ZONING AMENDMENT STAFF REPORTDate: June 5, 2014

NAME JCP Investments, LLC (Don Williams).

LOCATION 4436 Government Boulevard

CONTEMPLATED USE Rezoning from B-2, Neighborhood Business District, to B-

REZONING FROM B-2 TO B-3

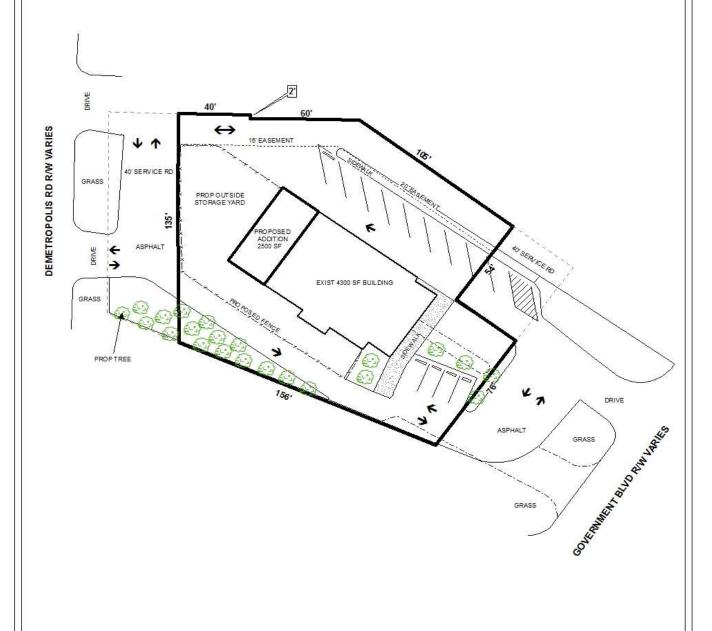
It should be noted that there appears to be a slight discrepancy in relation to the dimensions of the submitted site plan and the Final Plat for the site, recorded in 1976. Discrepancies may have an impact on site compliance to include landscaping requirements, for instance. As such, a revised site plan should be submitted to reflect the correct dimensions of the site.

It should be pointed out that the proposed parking spaces on the Northern portion of the site do not contain any bumper stops or curbing and two of the proposed spaces are depicted within the right-of-way of Government Boulevard. As such, the applicant should be advised that a right-of-way use agreement may be required or the applicant may request a street vacation. Also, no accessible route is depicted from the accessible parking space to the building and, although the Planning Section does not enforce accessible parking or ADA, certain aspects of ADA do impact site design. As such, any revised site plan or building plan should comply with Section 64-6. of the Zoning Ordinance, in addition to design compliance with the requirements of the ADA, in accordance to the applicable building code section 1106 (and 2010 ADA Standards for Accessible Design), at the time of permitting.

It should be pointed out that fencing on the site may be an issue. There appears to be an existing privacy fence along the Northeastern property line which is not depicted on the site plan and the applicant now proposes a 6' wooden privacy fence around the proposed storage area, which includes a portion of the western property line. As the site is considered a double frontage lot, the required setbacks may differ slightly than the typical 25'. Due to the proximity of this site and the adjacent commercial site to the Northeast, and the proposed traffic circulation around the site, Staff questions visibility as it appears that a 6' wooden privacy fence may cause line of site issues.

In reference to vegetation, trees and landscaping is illustrated on the site plan, however, 7 frontage trees appear to be depicted within the right-of-way and, as such, may not be counted towards the required number of frontage trees. Also, several trees appear to be proposed within 15' of above-ground utility lines, although not identified on the site plan. The applicant should keep in mind that any trees planted within 15' of above-ground utility lines **must** be live oak trees. Therefore, the site plan should be revised to illustrate live oak trees but if the applicant desires a different type of frontage tree, they should be depicted a minimum distance of 15' from the overhead utility lines.

It should be pointed out that there is no dumpster clearly identified on the site plan. The site plan should be revised to illustrate the location of a dumpster in compliance with Section 64-4.D.9. of the Zoning Ordinance, or a note stating that waste removal will be via curb-side pick-up.

It should be noted that a sidewalk is also not illustrated on the site plan along the street frontages.

Lighting is not illustrated on the site plan. Any new lighting on the site will have to comply with the requirements of Sections 64-4.A.2., 64-6.A.3.c., and 64-6.A.8. of the Zoning Ordinance. A note reflecting this requirement should appear on the site plan, and photometric plans may be required at the time of permitting.

Overall, the site and tree plan should be revised to quantify and illustrate full compliance with the Frontage Tree requirements of the Zoning Ordinance and, if it is determined that the
